CITY PLAN COMMISSION

Conditional Use Permit for a Distribution Facility to be located at the Northwest Corner of 38th Street and the West Frontage Road. (ULINE Distribution Facility) (District 16) PUBLIC HEARING

SUBJECT: PLAN REVIEW COMMENTS

Project Description: Uline Development – 100% Plan Review (4th Submittal)

SITE DIMENSION & PAVING PLAN

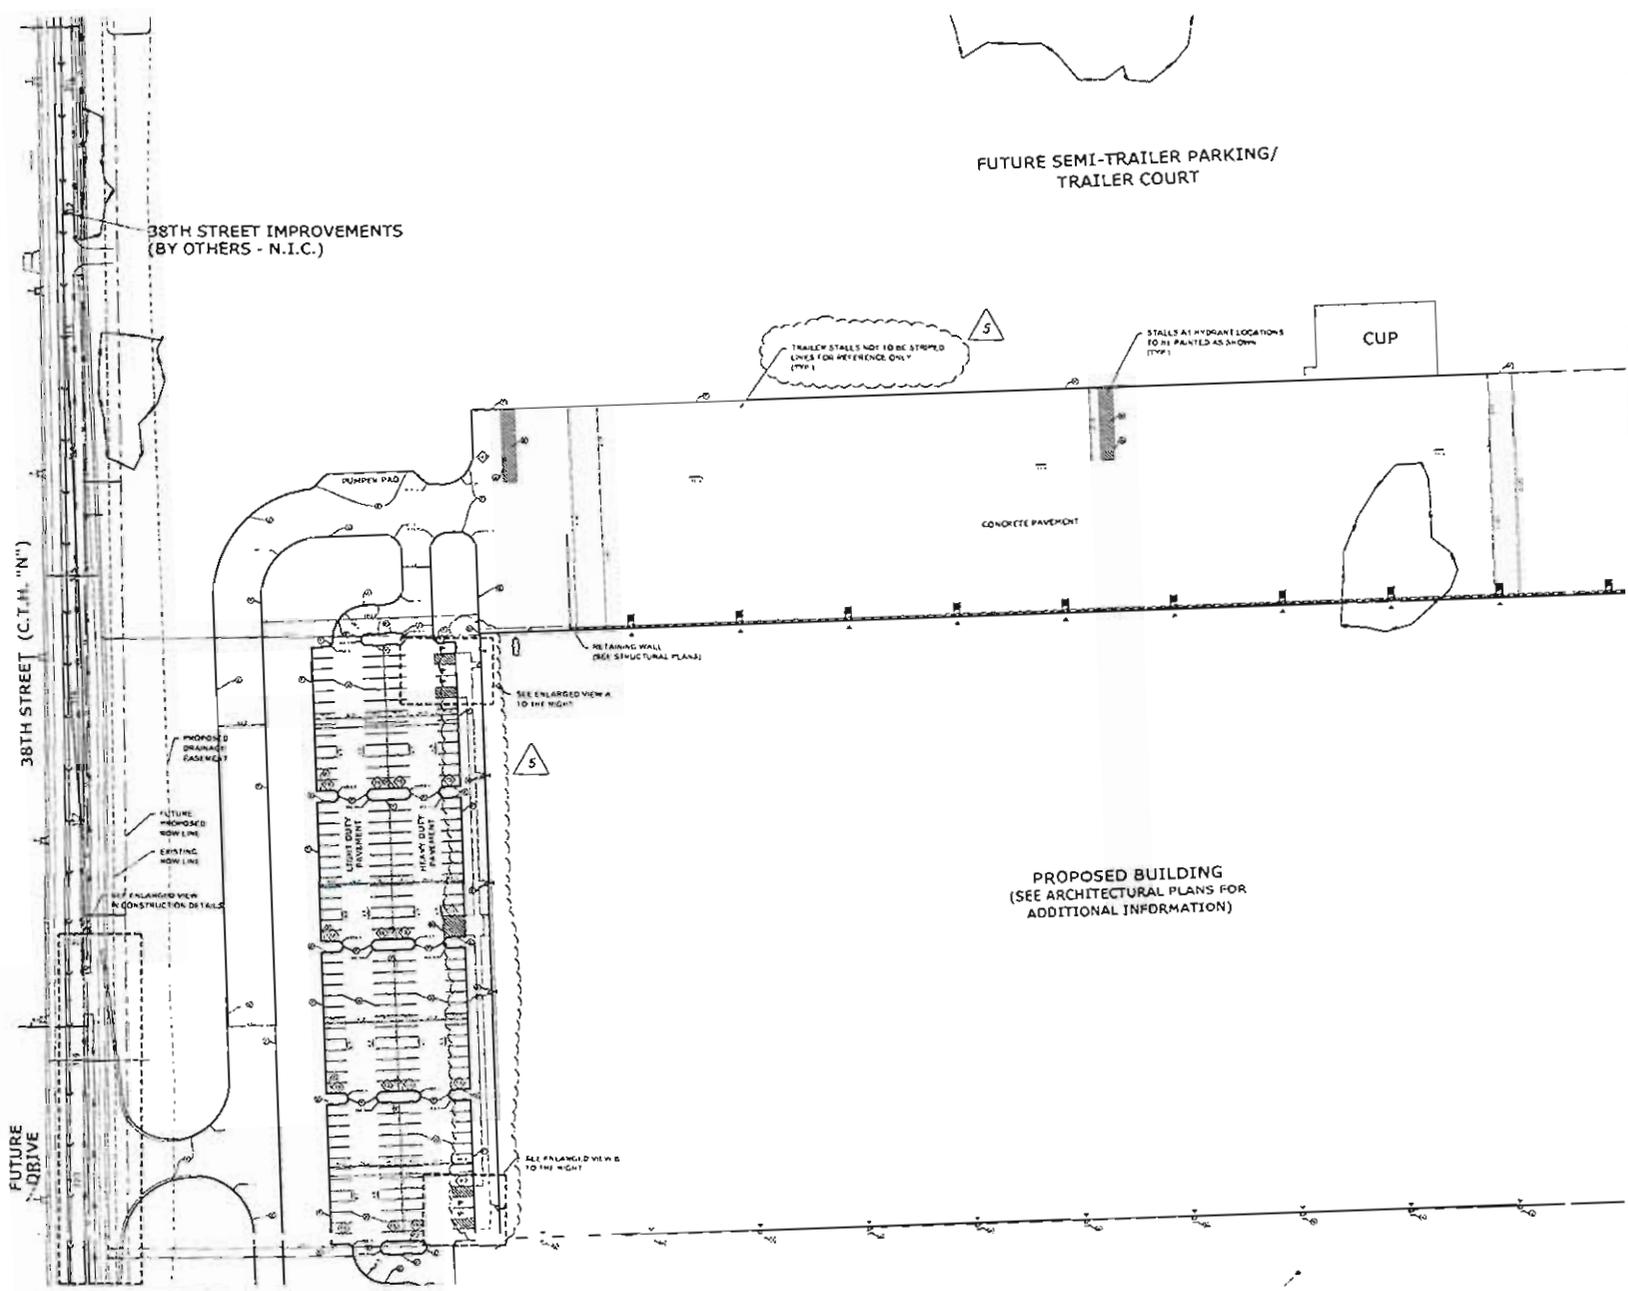
10. Typical section call-out on Sheet C-9 refers to look elsewhere, but not sure where this is referring to since there is no typical section in the construction detail sheets. COMPLETED

GRADING PLAN

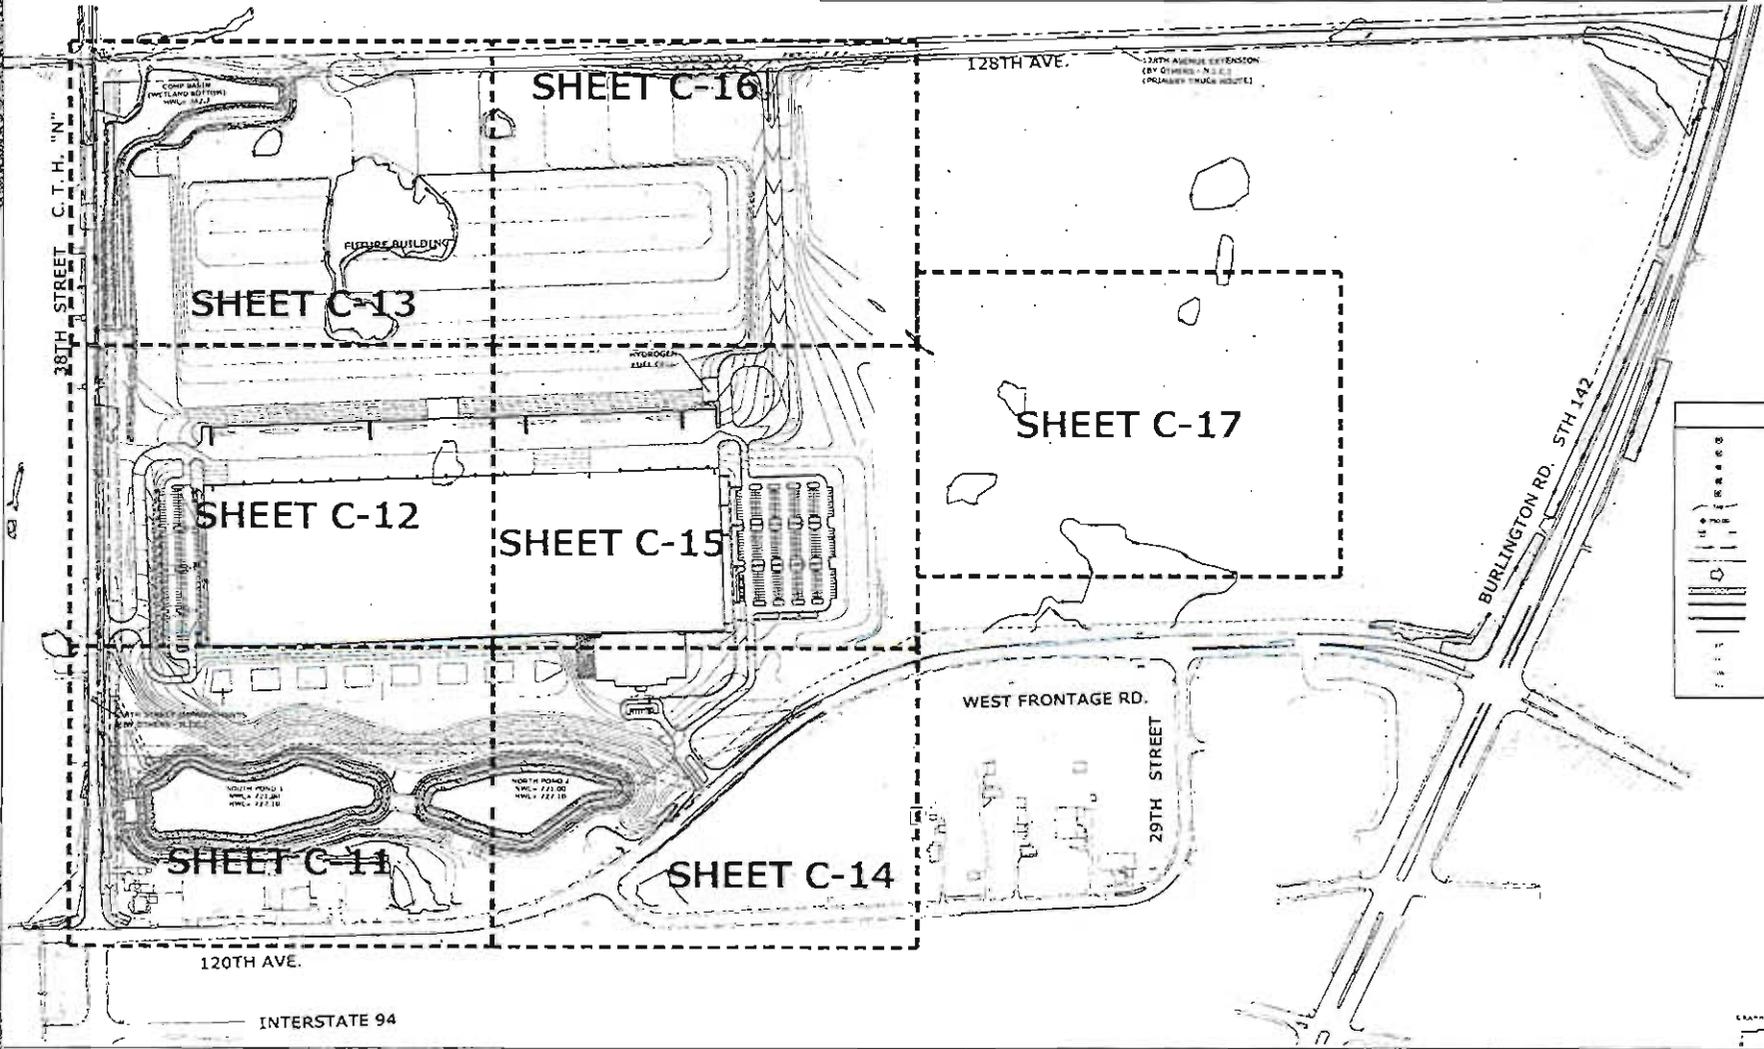
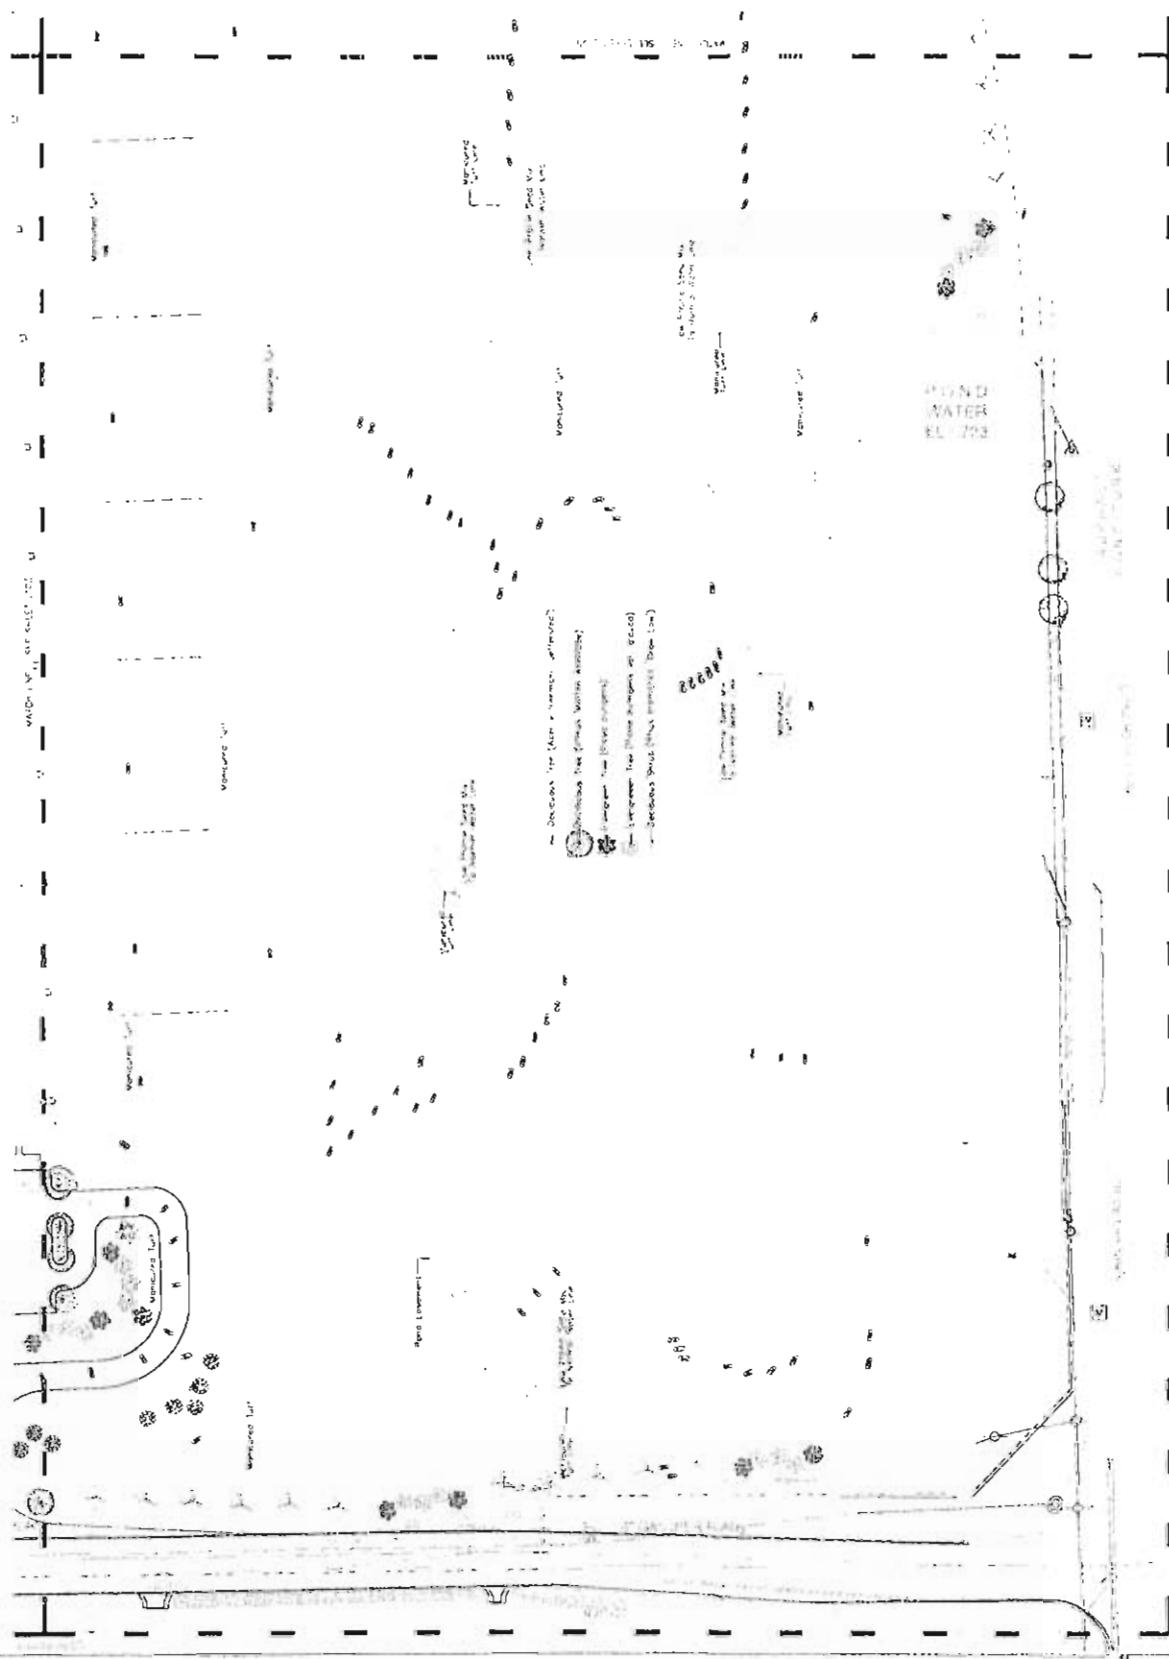
30. The plan set need to be updated to show the revised overflow weir sizing and location. The SWMP refers to a 135' weir (in two locations); however, the detail in the SWMP indicates a 70' weir and the plan set still shows a 30' weir. Furthermore, the grading plan needs to be updated to show the most recent locations of the overflow weirs. COMPLETED

32. Clarify what the normal water level of the north and south ponds are. The grading plan and utility plan do not match (722 and 721). SWMP states 721. COMPLETED

33. Label elevation of the emergency spillway of 727.80. COMPLETED
34. Mark wetlands that are being eliminated with a "X" and label them "Part of DNR general permit" COMPLETED
